**CALIFORNIA COASTAL COMMISSION**

**STAFF REPORT: PERMIT AMENDMENT**

**APPLICATION NO.:** A-5-RPV-93-005-A13

**PROPOSED AMENDMENT 13**

A 5 RPV 93005 A 13 Exhibit 4  
proposed trails CA19 temporary substitutes for  
A 11, 12 + 13

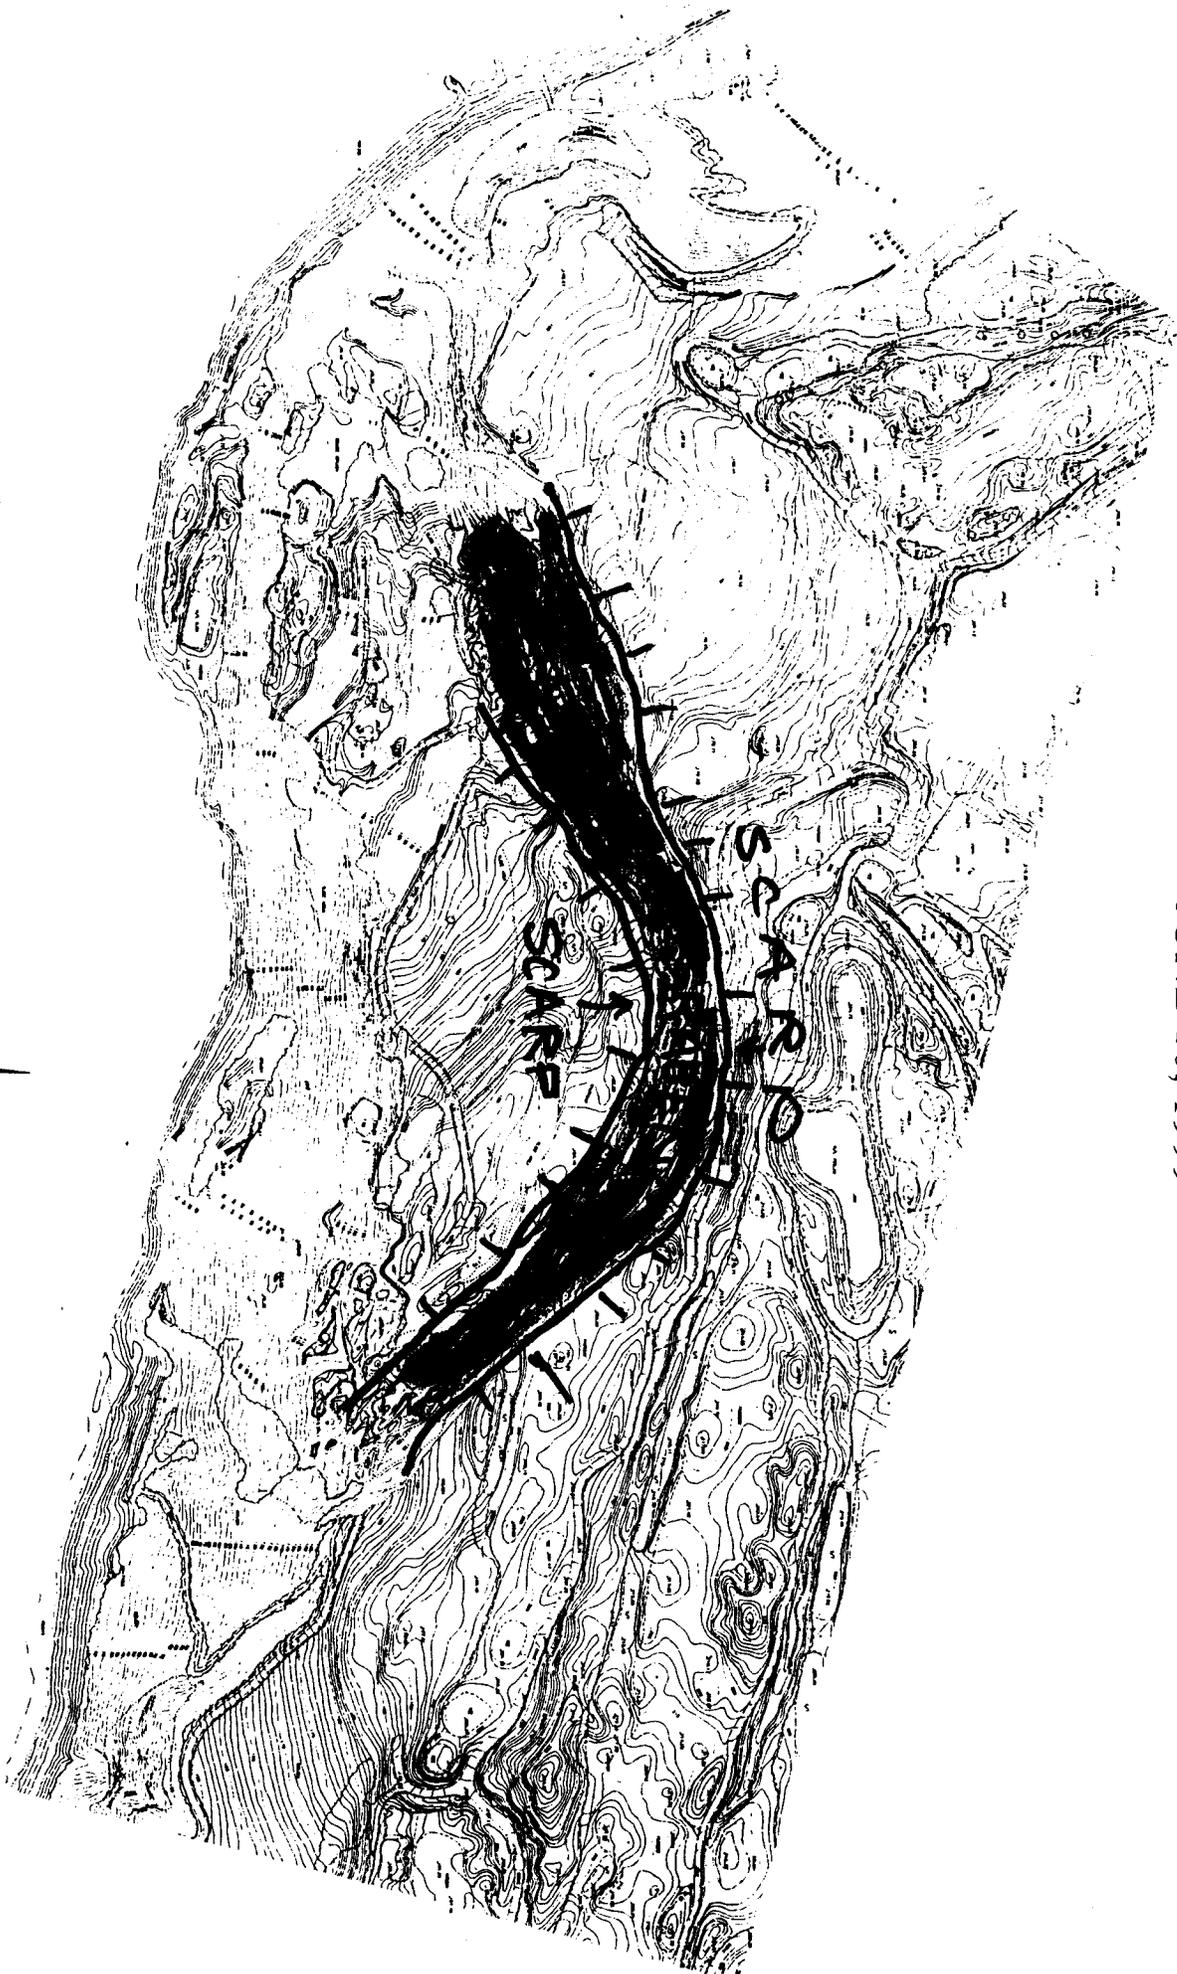
In the interim, the applicant proposes to 1) provide a temporary trail to link the public parking lot to the bluff top via the golf course paths; and 2) re-route and open the Dudleya Trail, and 3) open a public seating area mini-park on the safer portions of the 5.2 acre Halfway Point Park until the entire park can be re-opened, 4) route an on street bike route on Ocean Trails Drive to keep it a safe distance from a construction trailer. (Exhibit 4)

The applicant proposes no change in conditions that tie the opening of the golf course to the completion of ALL the golf course and tract 50667 recreation facilities. Staff is recommending approval of the above-identified changes, with conditions to assure that the proposed substitute trails are open before the clubhouse can open.

*A5 RPV 93 005 A13 Exhibit 8*

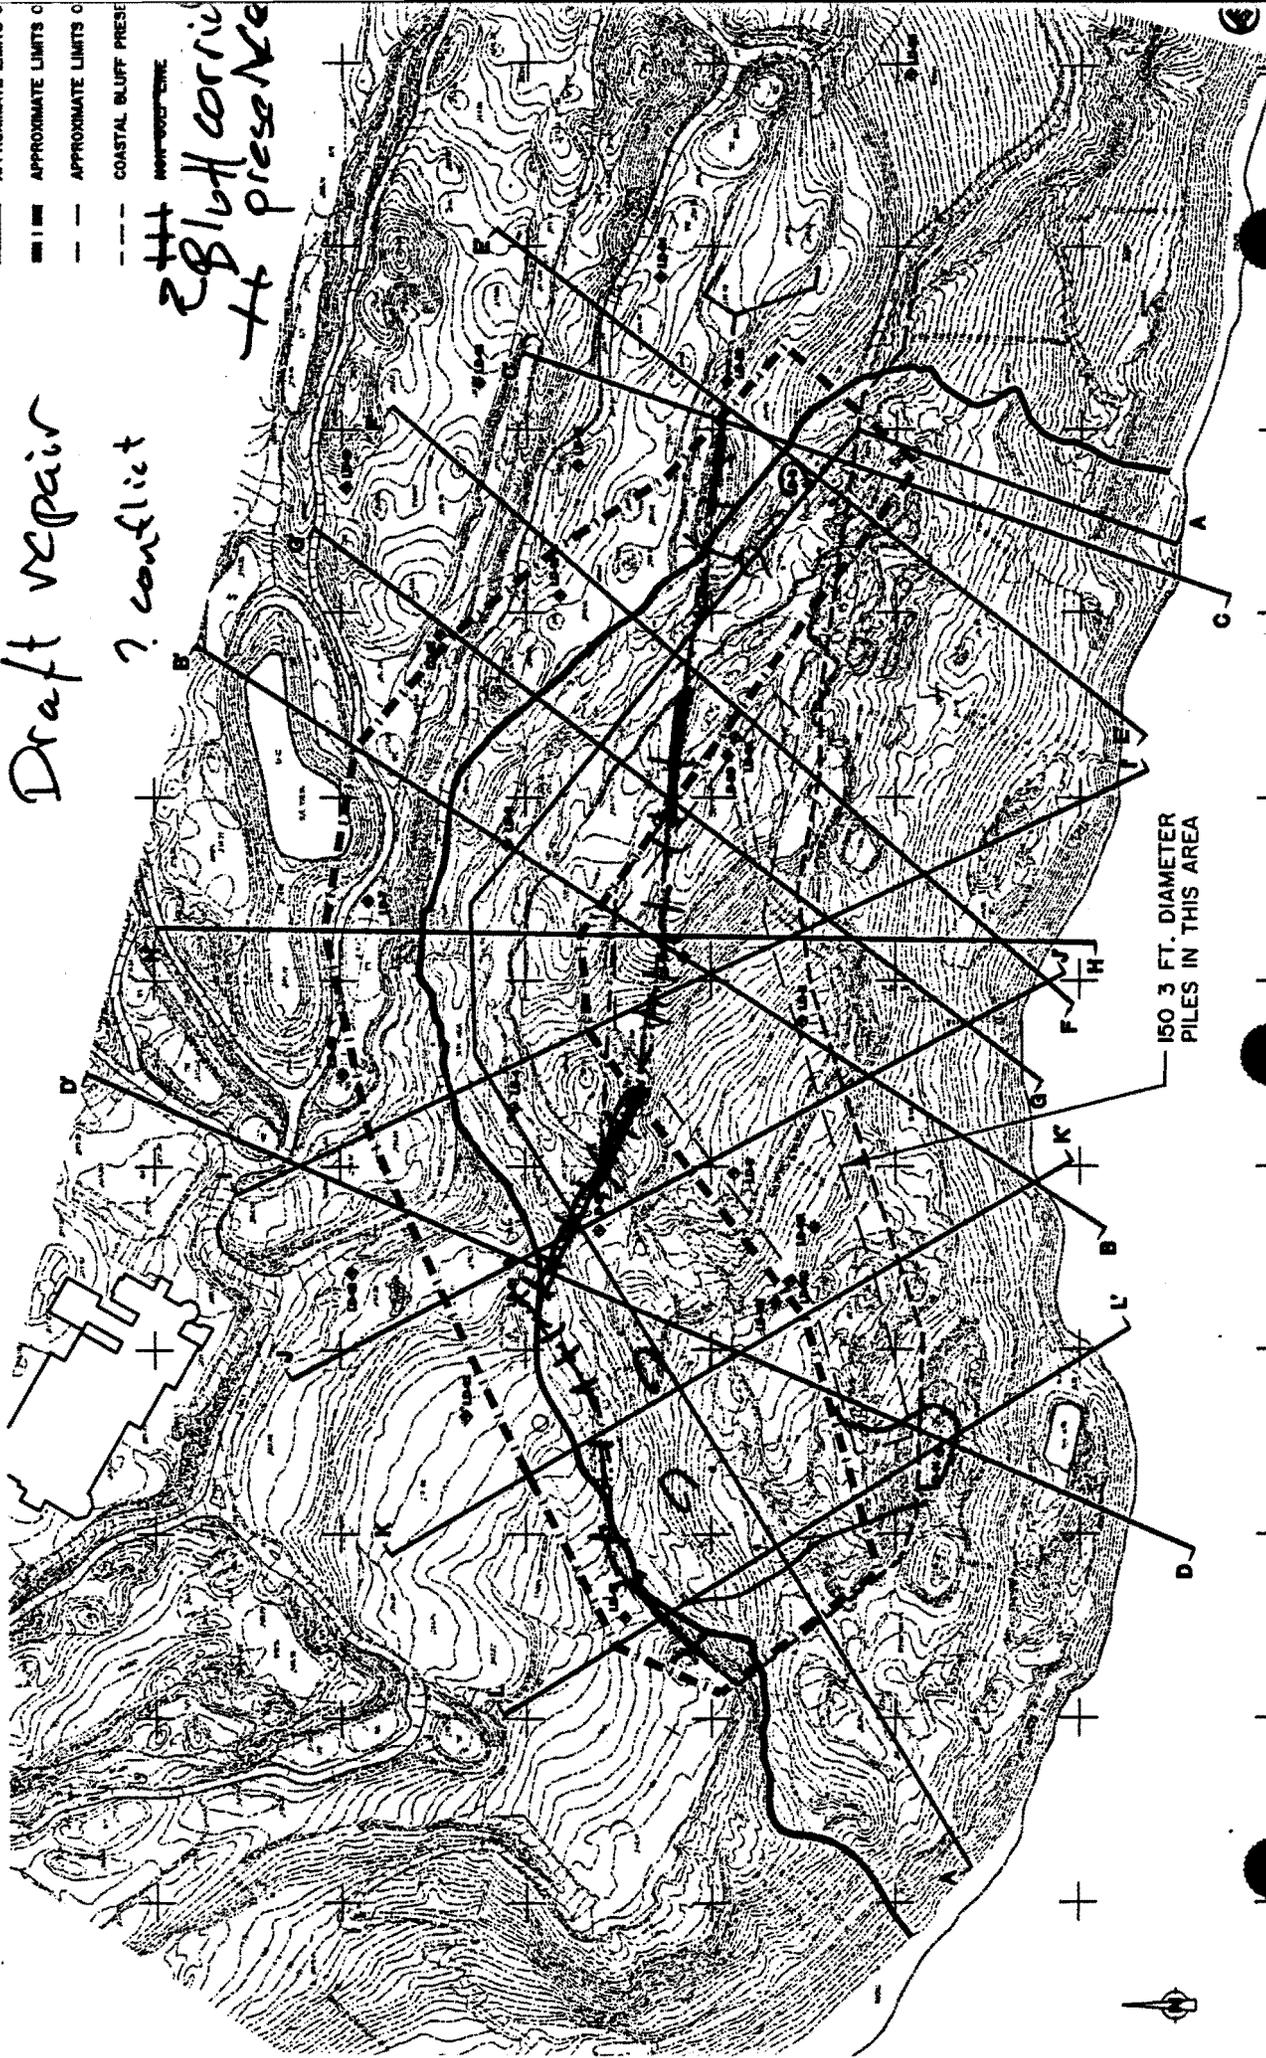
As part of this permit amendment, the applicant also proposes the first phase of stabilizing the areas damaged by the slide. Cracks have appeared on the cliff edge at Halfway Point Park. The applicant proposes to divert water from these cracks, and fill them to defer removal of the entire rock block. In addition, approximately seventy six cracks and fissures in the main landslide block could allow water to percolate into the slide, potentially reaching the bentonite layer at the slide plane, that lies 90 feet below the surface of the slide. These cracks vary from a few inches to over ten feet in width and similarly vary in length and apparent depth. Originally, some fissures reached 90 feet, although presently sloughing of the crack walls has created bridges. The applicant proposes to fill these cracks with rocks or earth and top the materials with "impervious" clay soil. The fissures will be marked for safety, bordered by sandbags as an erosion and surface water control measure. (Exhibit 6)

2) Crack filling. The City's geological consultant and the applicant's consultant want to fill the cracks and fissures in the slide block with dirt and rocks and top it with relatively impermeable material. Many of the cracks and fissures are open down to the bentonite layer. The open cracks and fissures will provide a direct conduit for rainwater to reach the bentonite layer. Not filling and sealing the cracks and fissures could result in the slide moving again when it rains. However, additional details are needed about the methodology to assure the filling will not make things worse, before the longer term site stability work can begin. Most of the cracks are in areas identified as Public Park (Bluff Top Corridor) in Condition 1 although some cracks are on the golf course. They range in width from a few inches to a few feet. While originally some of the cracks were 90 feet deep, some of them are only 30 to 50 feet deep by now, as a result of sloughing of the crack walls. However, the open cracks preclude all public access to the area and are also hazardous to workers.

A 593 005 A13 — 80 TO 120 3 FT. DIAMETER  
 PILES IN THIS AREA  
 Exhibit 9 Piling sites

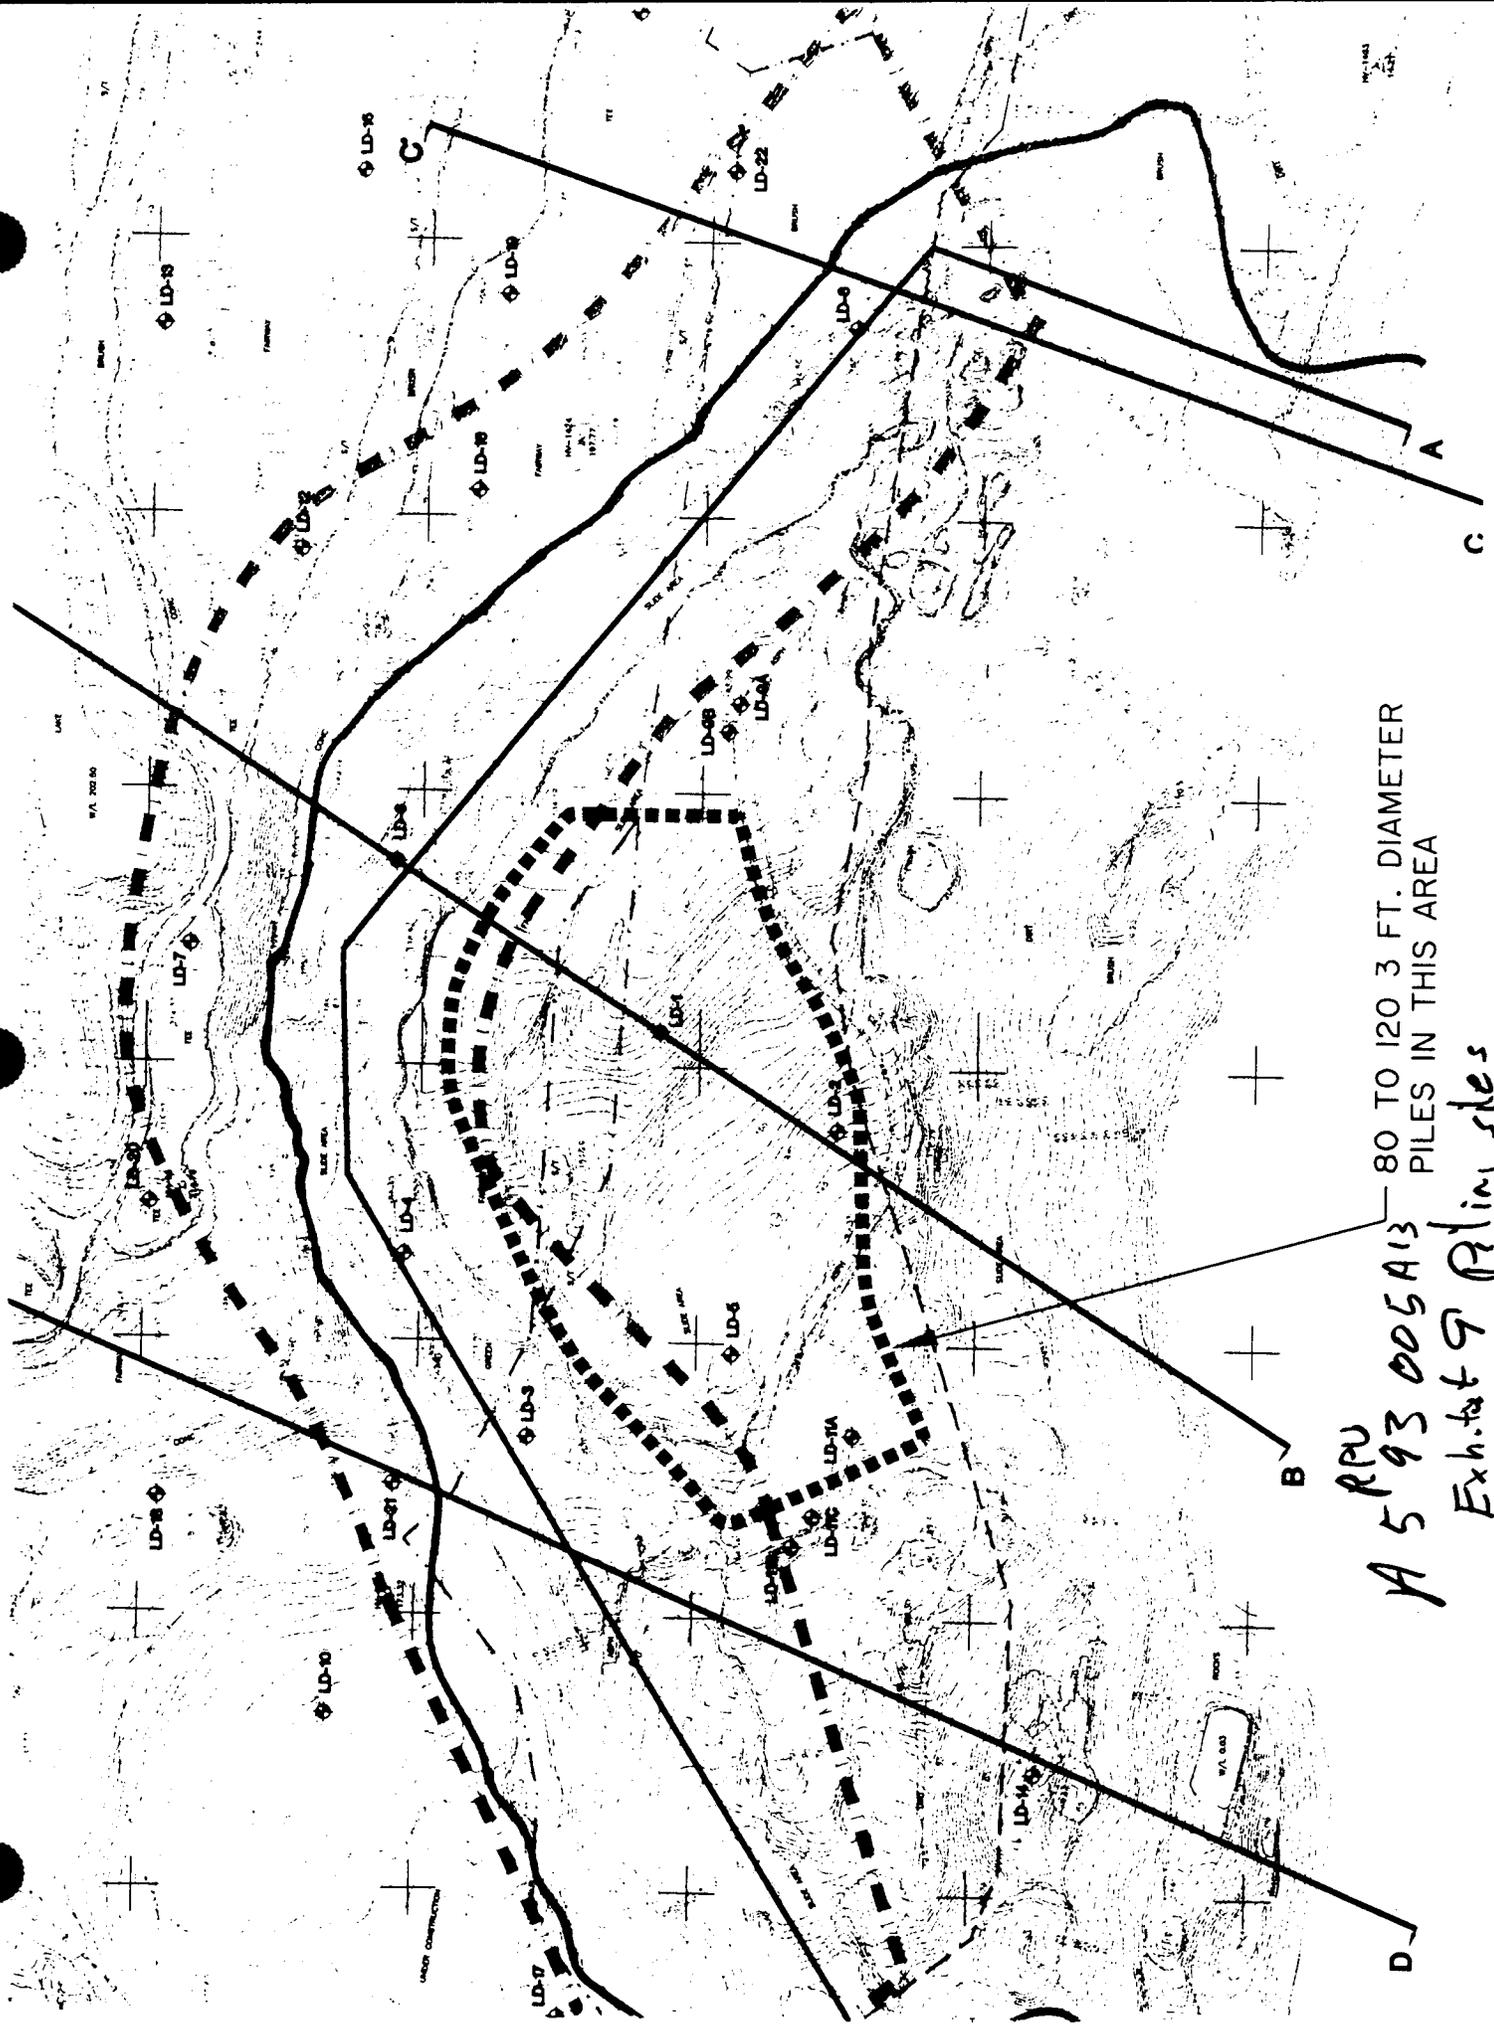
6) Placing shear pins (caissons), in the "big block" area of the slide. This five-acre area moved as a flat-topped block. It has been fairly stable since June 2<sup>nd</sup>, but could move again when it rains. The applicant's consultant proposes drilling approximately 150 holes about 11 feet deeper than the bentonite layer, inserting into each of these holes a 3 foot diameter shear pin that will extend through the bentonite layer, cutting the shear pins off about 11 feet above the slide plane (the bentonite layer) and back filling each hole. The City geologist concurs that this is an acceptable method to slow a slide, but has not yet received adequate strength and stability calculations for a thorough review of this portion of the project. The applicant believes that shear pins should be installed when the cracks are filled. This will create, in its view, maximum stability, and will allow all work to be completed before the rainy season. This would allow it to move forward with revegetation and other work it is considering and would allow trails to be replaced in this area. It is not clear however, that the block could ever support paved trails. The bluff top corridor is a dedicated habitat area that is located in the slide. This part of the project is conceptual and requires the several phases of additional review from the City geologist. The City did not give its approval for this work. For this reason, staff does not recommend approval of the shear pins as part of this amendment. This plan could be presented to the Commission when the applicant's proposal for a retaining wall on hole 18 is presented. The Commission could consider all alternatives, including simply re-locating the access features onto the seaward edges of the stable land. With the entire plan before it the Commission could consider whether the entire design is the least visually obtrusive design and consistent with access over and revegetation of the block.
